REF: N155982

DATE: 3 February 2020

RE: BREWERY YARD BUILDING, CENTRAL PARK (SSD 9374) – RESPONSE TO SUBMISSIONS

Figure 1: Locations of loading options

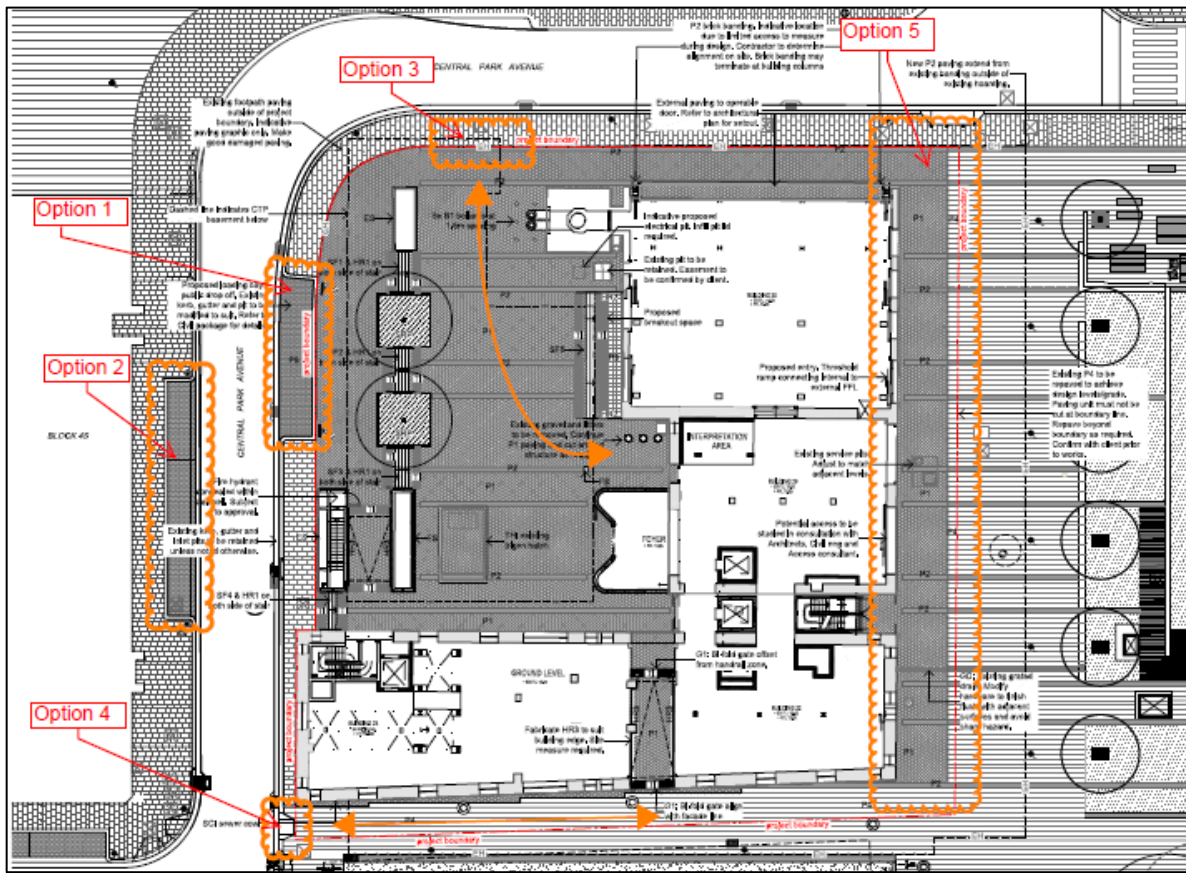
- *The RtS notes that discussions are currently occurring with the City of Sydney regarding the parking zones on the west side of Central Park Avenue and alternative loading and servicing arrangements within the site. The Department requests these revised arrangements are finalised prior to submission of the RtS for consideration in the assessment.*

The indented bay along the western frontage of Brewery Yard was proposed as part of the SSDA, with pedestrians able to use the building forecourt/ public domain to navigate a parked vehicle. City of Sydney did not support this option due to its impact on the pedestrian footpath and diversion of pedestrians into private property when a vehicle is parked.

This option would require at least two parking spaces within the existing indented parking bay on the west side of Central Park Avenue (which has two-hour/four-hour time restrictions for three car spaces) to be converted to a dedicated 12-metre loading zone during business hours. To accommodate the delivery drivers and removalists, appropriate kerb ramps would be required on either side of the road.

Option 3 would allow vehicles to reverse into the forecourt area and exit in a forward direction. The vehicle parking location would be within the Brewery Yard site to minimise the impact on pedestrian movements along the footpath. Removable bollards could also be installed to restrict the time for deliveries and access into the forecourt as another measure to encourage deliveries to arrive at scheduled times.

A limitation to this option is the Central Thermal Plant for the Central Park Precinct which is located below the forecourt. The forecourt area also has an existing easement for the Central Park Precinct which may affect access permission.

The location of the vehicle crossover for Option 4 is not recommended given that it is within the intersection of Central Park Avenue and Irving Street, which is non-compliant with the relevant Australian Standard. A vehicle stopped in the pedestrian area along the southern side of the building will also impede pedestrian movement.

Option 5 is not recommended given that it is within the intersection of Central Park Avenue and Chippendale Way, which is also non-compliant with the relevant Australian Standard. It would also have a significant impact on pedestrian accessibility and safety within the public domain. It is further understood that there is an easement in favour of the CTP operator for vehicular access over the area in consideration for crane access to the top of the Trigeneration building, which may occasionally restrict access for loading activities.

Utilising other loading docks within the precinct may be considered, however the respective travel distances would likely result in delivery vehicles utilising the existing parking bays or illegally parking temporarily along Central Park Avenue. As such, Option 6 should only be considered if no other options are feasible.

As noted by the Department, the project team has been discussing an on-street primary loading and servicing solution for the site with the City of Sydney. Specifically, this is proposed to involve the conversion of existing short-term indented parking spaces on the west side of Central Park Avenue, to a loading zone during business hours. While City of Sydney officers have not raised any objection to either an on-street parking solution or the above revised proposal, the project team has been advised that any proposed changes to on-street parking restriction would need to be referred to Local Pedestrian, Cycling and Traffic Calming Committee (LPCTCC).

GTA recommends that Option 2 of converting two existing indented parking bays on the west side of the Central Park Avenue to a loading zone during business hours be pursued. In addition, Option 3 of installing a layback along the northern boundary of the Brewery Yard for vehicle access to the forecourt area is recommended for waste collection and removalist demand outside business hours. Providing both opportunities would allow flexibility and still accommodate delivery and servicing needs (via Option 3) should there be a need to change on-street parking arrangements (Option 2) in the future. It should be noted that GTA still considers Option 1 to be a practical and feasible solution, with minimal impact to pedestrian movement.
